WELCH ST., PEARL ISLAND
84-K-4-5

HEARING ON APPEAL UNDER THE ZONING ORDINANCE OF Randall MacVane Post #142

CITY OF PORTLAND, MAINE
Department of Building Inspection

APPLICATION FOR PERMIT

AMERICAN LEGION, PEAKS ISLAND, ME.

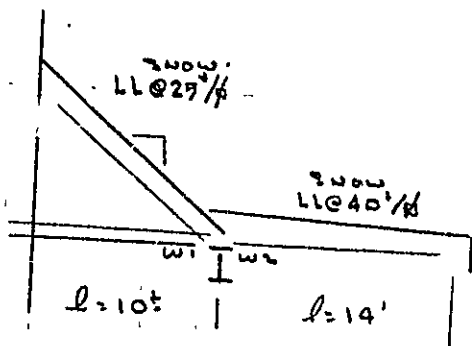
We will need a certificate of design for the steel beam on a 19' span between new and old kitchen. We question if this steel beam is adequate. We will need more figures on this beam before we can reach a decision.

We will need a certificate of design for the steel beam on a 19' span between new and old kitchen. We question if this steel beam is adequate. We will need more figures on this beam before we can reach a decision.

Studs in outside rear wall of addition are to go down to the double 2x4 inch girt plate of studs below.

SECTION A-A sheet 1

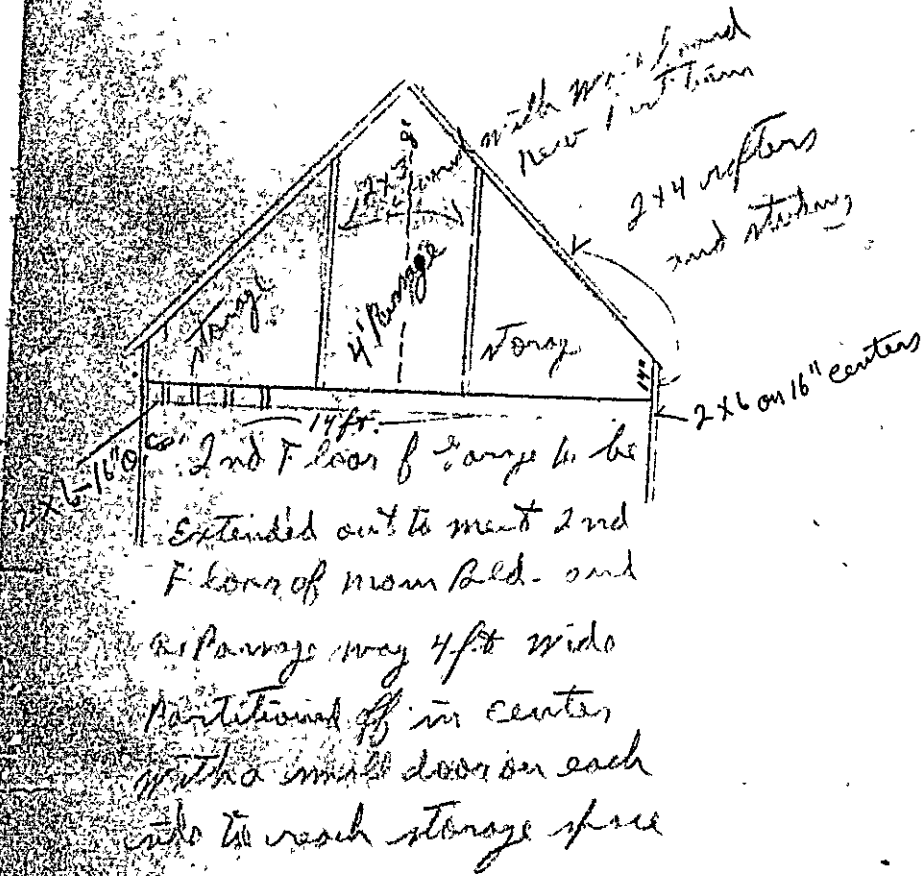
1. The final arrangement of rooms on the second floor is not clear on the plans and I am not sure as to the use of these rooms. I am assuming that there is no room on the second floor to have a floor area exceeding 800 square feet and no room to be used for assembly. This is important in that it has a bearing upon the protection of the heating plant and features of emergency egress.

2. The 2x8 floor joists on the second floor apparently are 25 inches from center to center. This is unusually far apart, but if the second floor is not to be used for the assemblage of persons, we will accept this arrangement without strengthening. If you have any plans for the future of having even a small assembly room in this second story as the strength of your steel construction would indicate, it would be well to provide 2x8 joists between each 2x8 joist under the second floor now so that the question will not arise later. There is no freaming of the rear portion of the second floor which will be the second floor of the present garage relocated and no indication as to its use. It is obvious that this floor must be used as a passageway to reach the rear exit stairway.

4. The floor joists under the assembly hall are indicated as being 25 inches from center to center. We are unable to approve this arrangement under Building Code standards. The 2x6 joists are amply heavy on this basis, but the question raised in the building code is the strength of the floor between the joists on the 25 inches span even though the floor is doubled. It will be necessary either to introduce additional joists between those existing or to take some definite means to strengthen the floor board spans between the 2x6's. The addition of joists is preferable.

We are not going to have any one room on the second floor over 300 sq ft. We plan to have a small entrance hall with 4 small office rooms to be used as offices & storage so as to keep every thing of that nature off the floor unless we have to show the exact place of these partitions at this time we would like to decide that later.
